Entrada Combined PZ-TC WORKSHOP

March 6, 2018

Pedestrian Bridge (Revised Design)

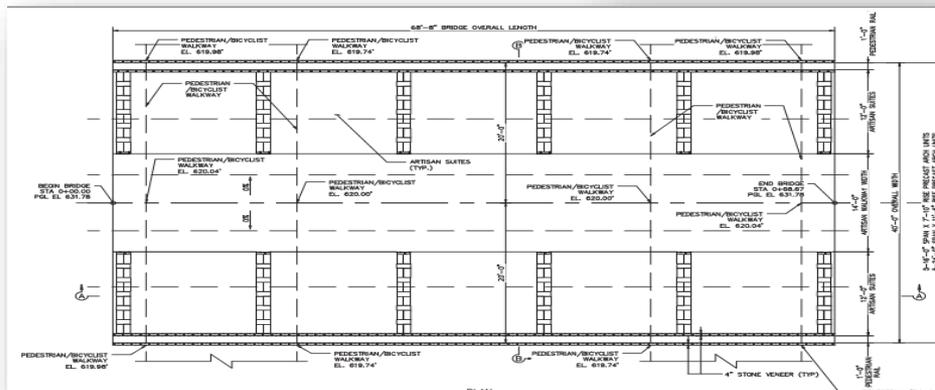
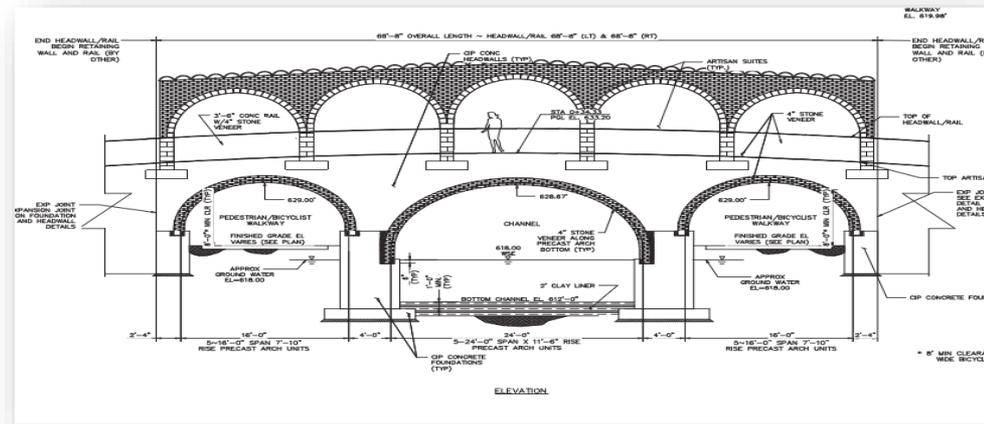
- Revised Design attached to the Civil set
- Lacks Tower
- Lacks gathering space
- Lacks covered walkway

Pedestrian Bridge (Comments)

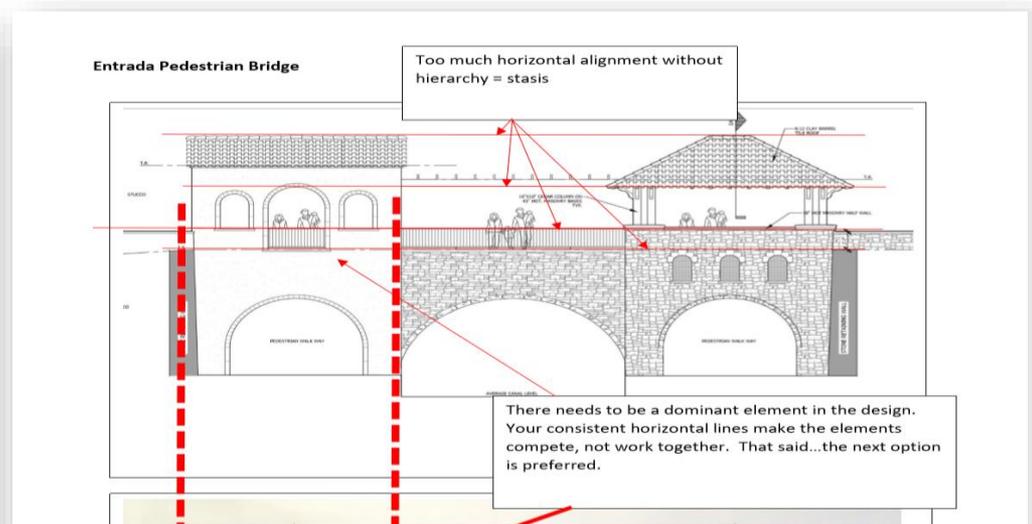
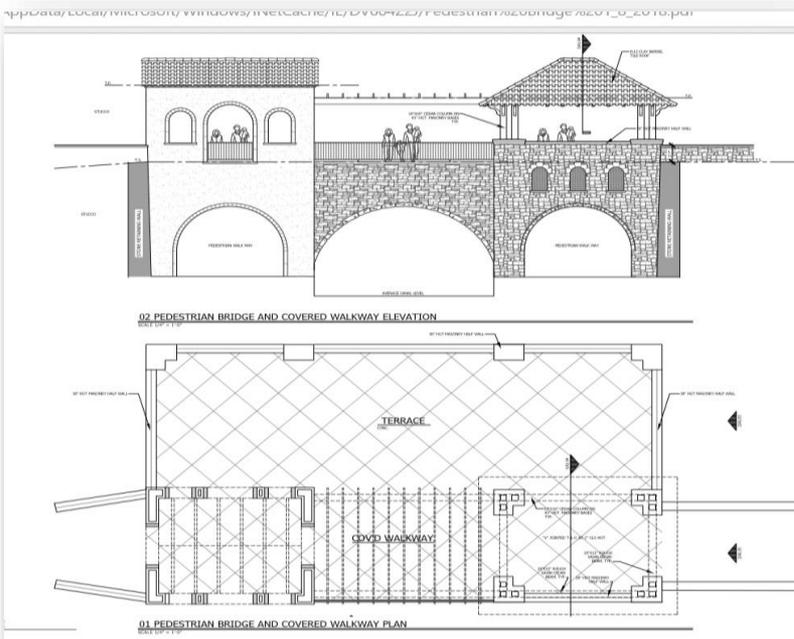
- Applicant's second design response with Town comments

Retail Corner Tower (Original Elevations)

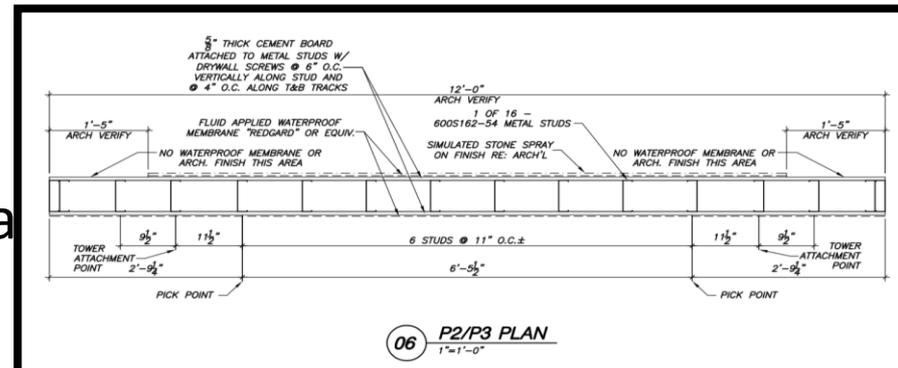
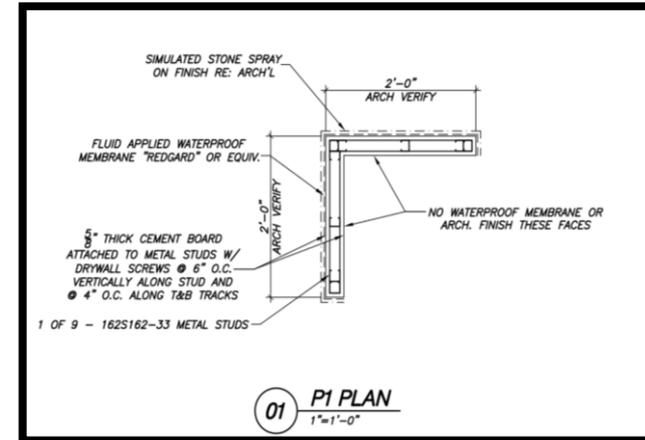
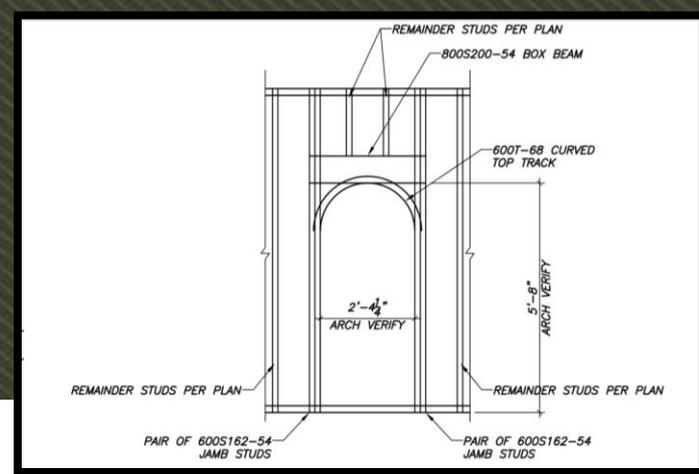
- Currently approved Merriman Design
- Not conducive to the use of a thin set stone or use of a material like Stone Coat
- Cannot hide required expansion/control joints

- Current design
- Vertical corners and horizontal bands allow the introduction of needed expansion and control joints
- Applies traditional stone construction techniques

Plaza Mayor (Original)

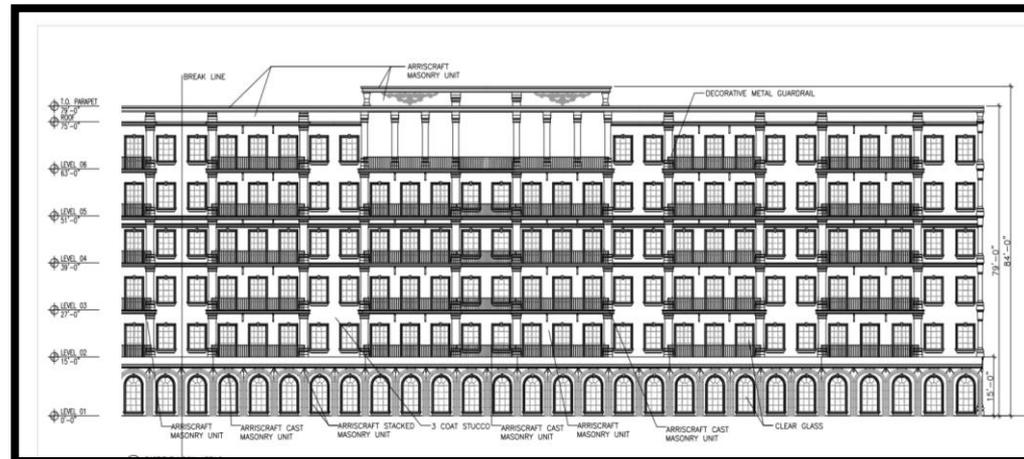
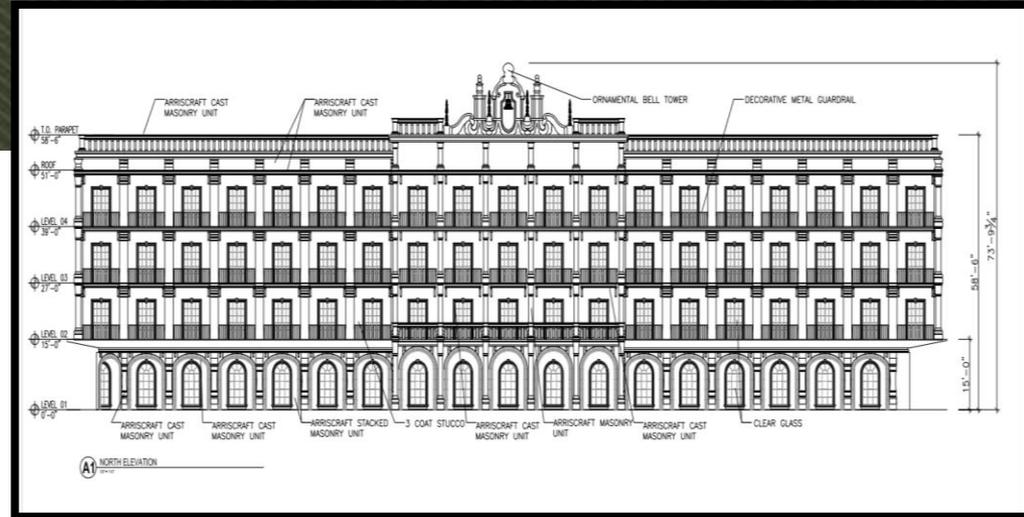
- Rhythmic features but needing **Baroque Opulence**
- Provides a good framework
- Needs more detail

Plaza Mayor (Comments)

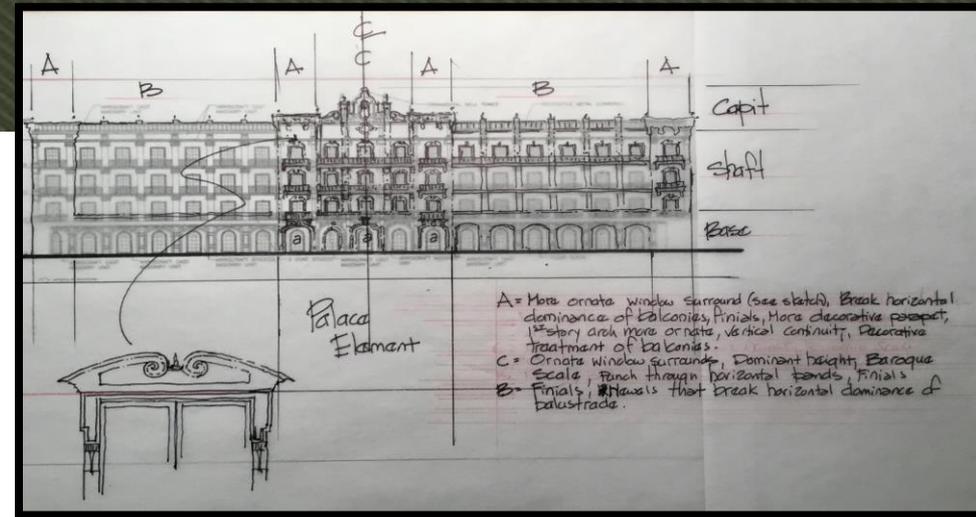
- Penetration of harsh horizontality with vertical ornament
- More classical detail
- More hierarchical form
- More opulence

Plaza Mayor (Most Recent)

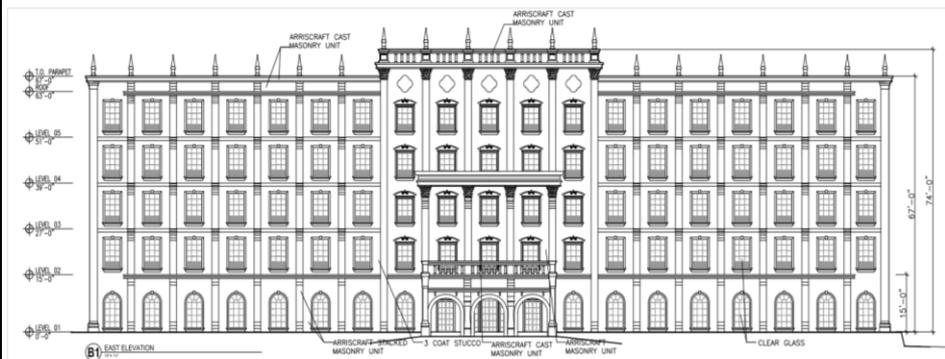
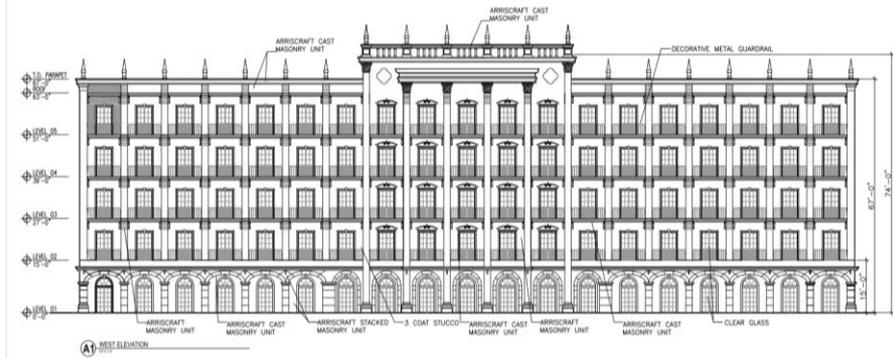
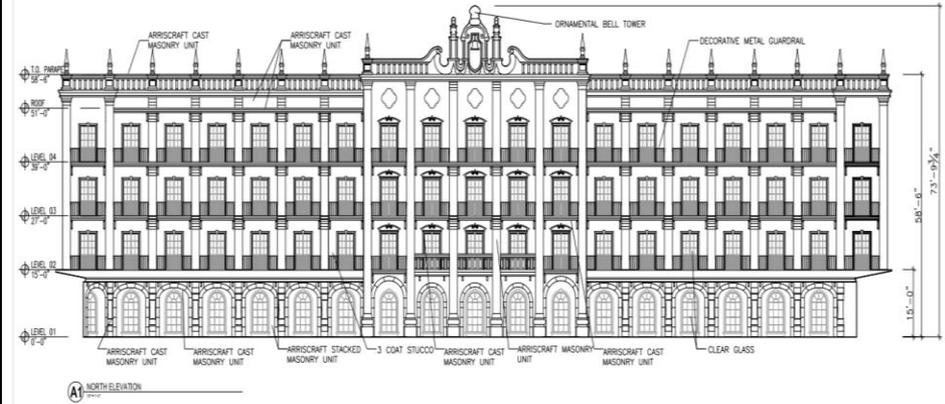
- Vertical extension
- Classical order
- Classical ornamentation
- More hierarchical form
- More detail at the Plaza level

Plaza Mayor (Most Recent)

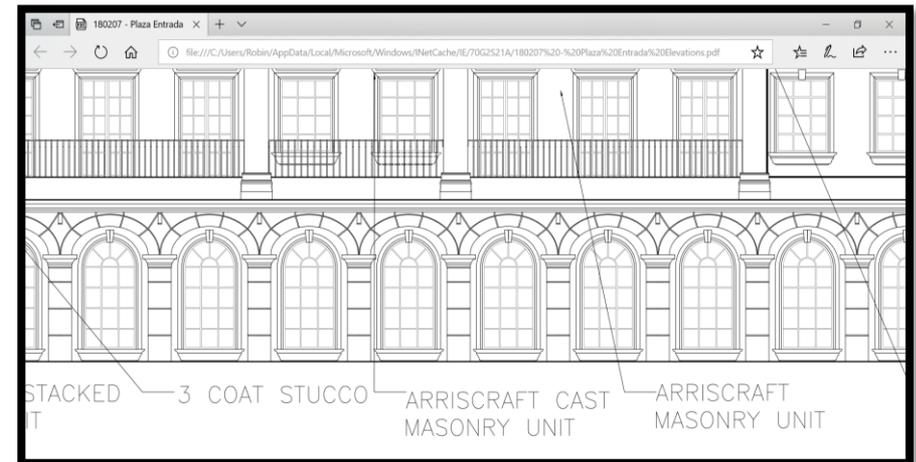
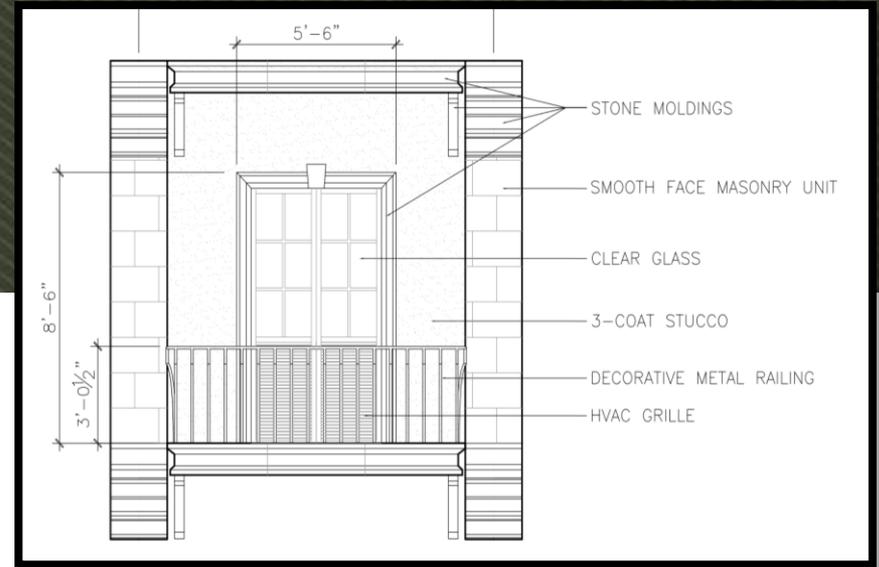
- **Attention to details** like concealing HVAC vents behind balcony rails
- Enhancement of **arcade supports** to match buildings referenced in the PD

Locations

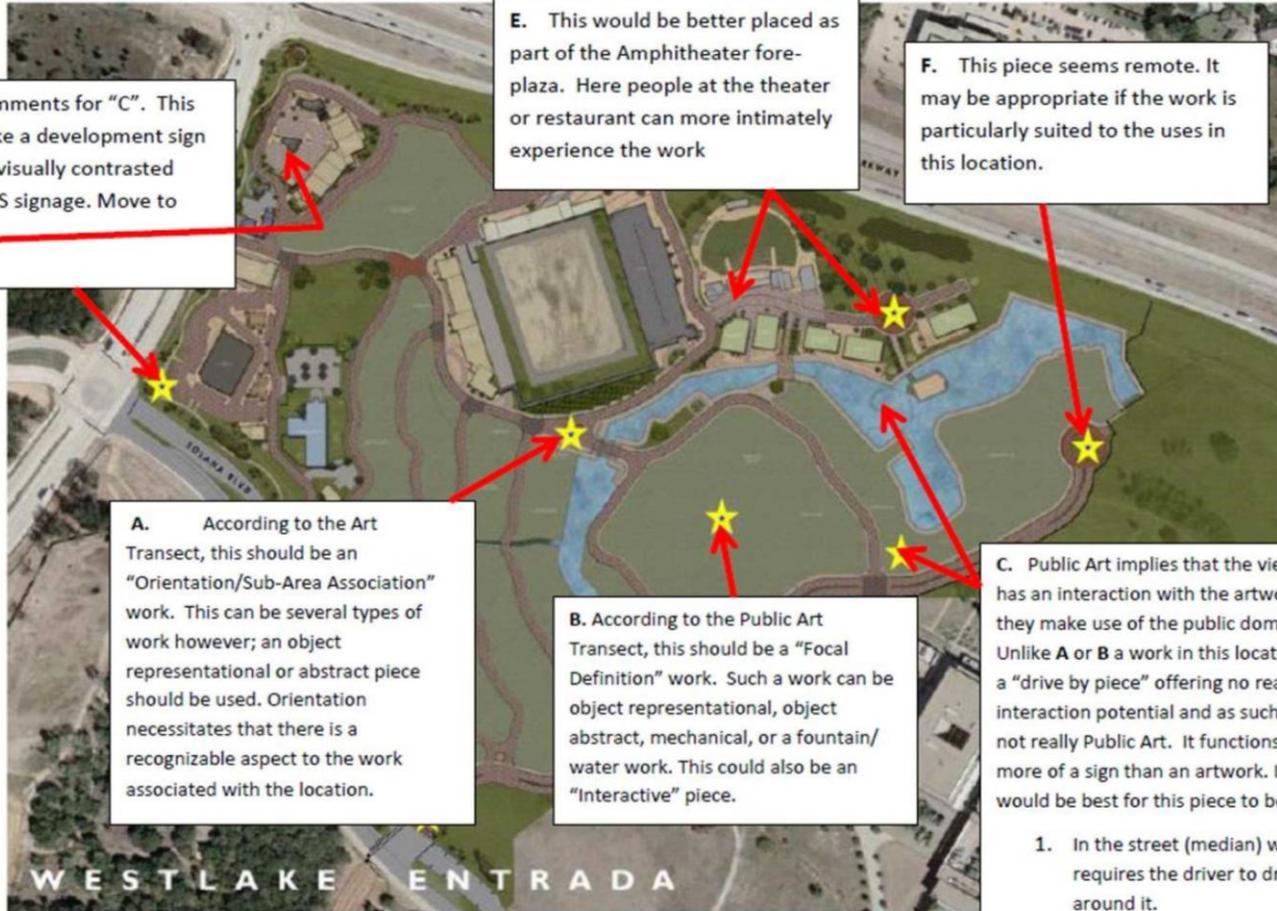
D. See comments for "C". This functions like a development sign and will be visually contrasted with the CVS signage. Move to here

E. This would be better placed as part of the Amphitheater fore-plaza. Here people at the theater or restaurant can more intimately experience the work

F. This piece seems remote. It may be appropriate if the work is particularly suited to the uses in this location.

A. According to the Art Transect, this should be an "Orientation/Sub-Area Association" work. This can be several types of work however; an object representational or abstract piece should be used. Orientation necessitates that there is a recognizable aspect to the work associated with the location.

B. According to the Public Art Transect, this should be a "Focal Definition" work. Such a work can be object representational, object abstract, mechanical, or a fountain/water work. This could also be an "Interactive" piece.

C. Public Art implies that the viewer has an interaction with the artwork as they make use of the public domain. Unlike **A** or **B** a work in this location is a "drive by piece" offering no real interaction potential and as such is not really Public Art. It functions as a more of a sign than an artwork. It would be best for this piece to be:

1. In the street (median) which requires the driver to drive around it.
2. In the water where it becomes part of the water experience.
3. Along a trail or in a public gathering area.
